# Bethesda Downtown Design Advisory Panel (DAP)

Project Name	4405 East-West Highway
File Number(s)	32022012A, and Site Plan No. TBD
Project Address	4405, 4419 and 4421 East-West Highway, Bethesda, MD 20814 and Parcel P224, PT LTS 6-10 in Block A

**4405, 4419 and 4421 East-West Highway Bethesda, Maryland**  
**Design Advisory Panel**  
**Sketch Plan Amendment and Site Plan**  
**June 14, 2023**

## DAP Recommendations

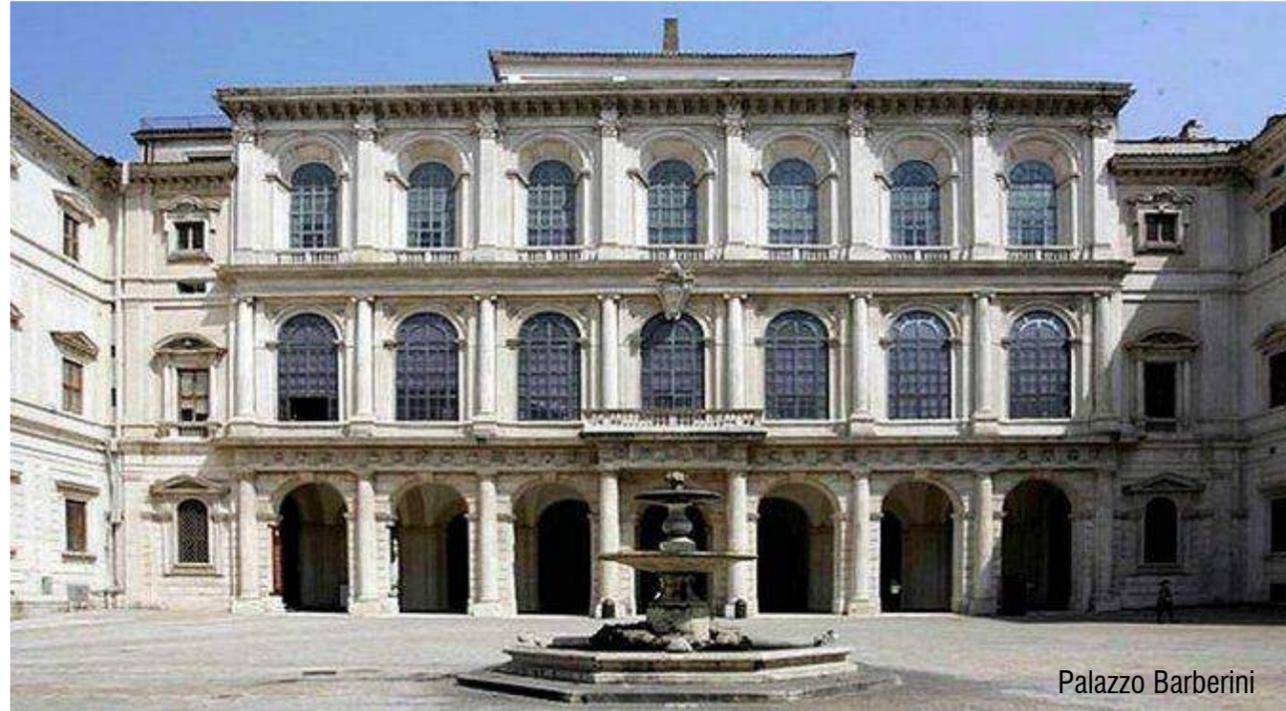
- Requested the project to return with refinement to the east and west façade.
- Requested further evaluation of the East West Highway façade based on the discussion.
- EW highway sidewalk activation
